**Report to General Manager**

**SUBJECT:** Planning Proposal 4/17 – 41 McLaren Street, North Sydney**AUTHOR:** Ben Boyd, Executive Strategic Planner**ENDORSED BY:** Joseph Hill, Director City Strategy**EXECUTIVE SUMMARY:**

**FIGURE 10: Loss of Harbour View**

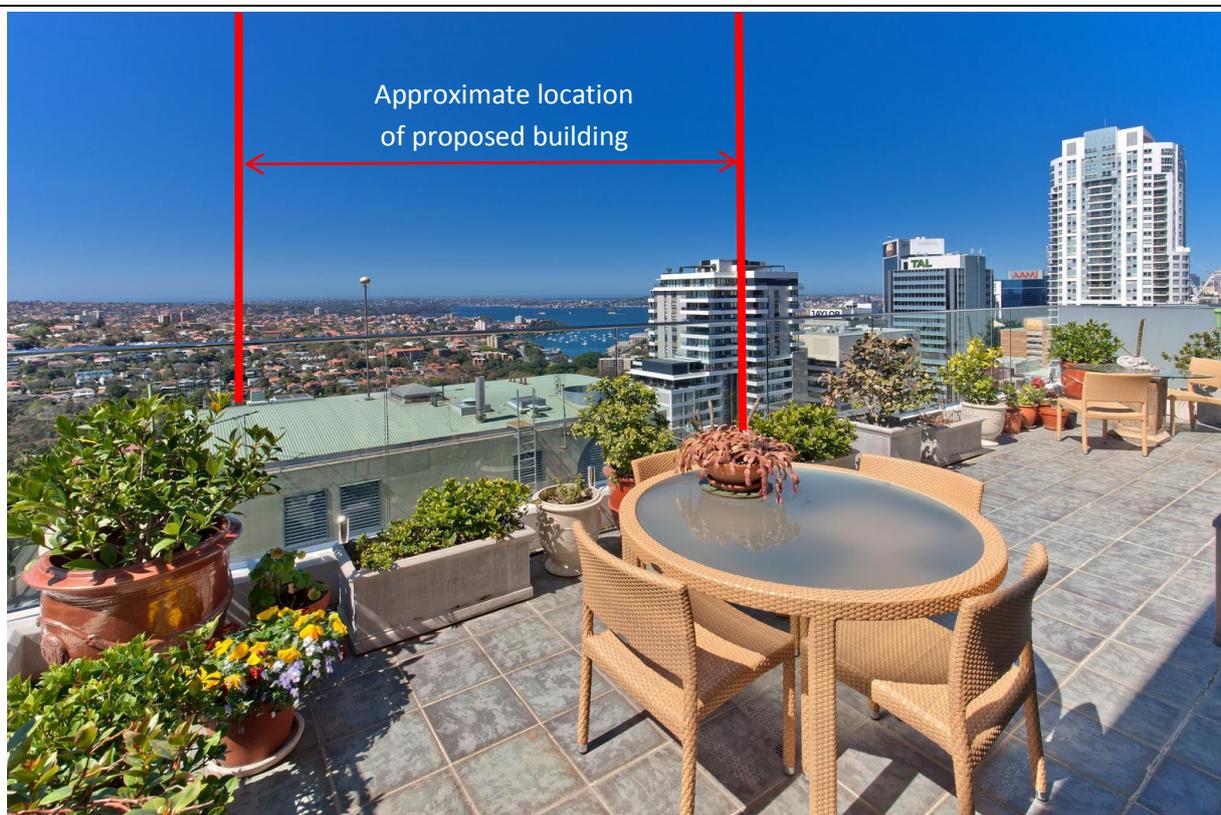
*Image taken from the main balcony of the top level of 239 Miller Street. The concept building proposal would result in the complete loss of the harbour views from this location.*

**FIGURE 11: Loss of Harbour View – as it relates to Figure 10**

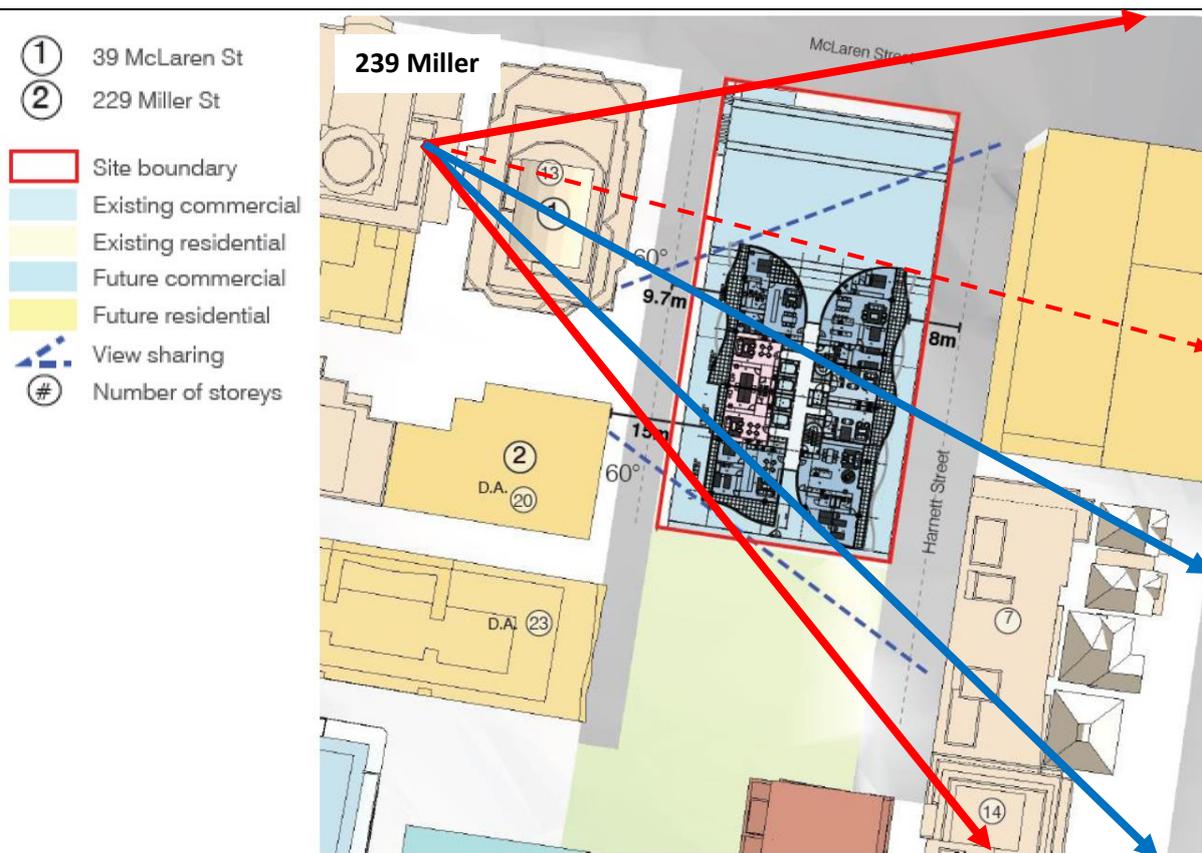
The Planning Proposal states that the proposal will only have an impact upon the views from dwellings at 39 McLaren and 229 Miller Street. Furthermore, it stated that the concept proposal has been designed to retain 60 degree angle views in Plan for these buildings, which is considered acceptable.

**FIGURE 12: Visual impact**

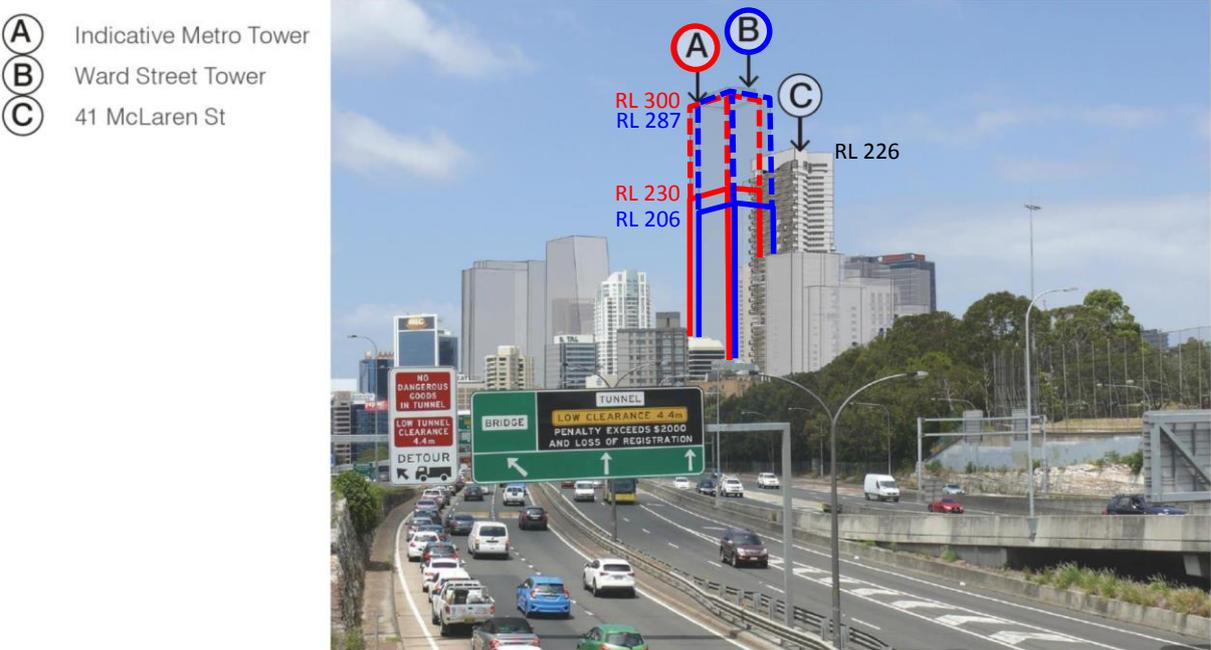
The Planning Proposal includes an assessment of the potential visual impact of a building on the subject site consistent with the proposed height. This assessment was made within the context of future development within the Ward Street Precinct as suggested under the applicant’s “Alternative Masterplan” for the Precinct. Given that the Masterplan is currently being reviewed and refined, there is no guarantee that the applicant’s “Alternative Masterplan” will be pursued. Furthermore, the assessment assumes that the over station development site on Miller Street will accommodate a 60 storey commercial tower (to RL 300m), when in reality it will be closer to 40 storeys at RL 230m which is consistent with the outcomes of the North Sydney Centre Review and the concept proposal issued by Transport for NSW with respect to obtaining the Secretary’s Environmental Assessment Requirements for the over-station development. This is a significant misrepresentation of the future context of the North Sydney skyline.

Building heights should generally be highest within the geographical middle of commercial centres and taper down towards its edges. The proposed height over the subject site is too high, given the Metro Station site would approximately represent the geographical middle of the Centre (the corner of Berry and Miller Streets) and presently it is proposed to accommodate a tower to RL 230m. FIGURE 12 represents the degree of contextual misrepresentation that the applicant has provided and indicates that the height proposal would be out of context with the remainder of development within the North Sydney Centre.
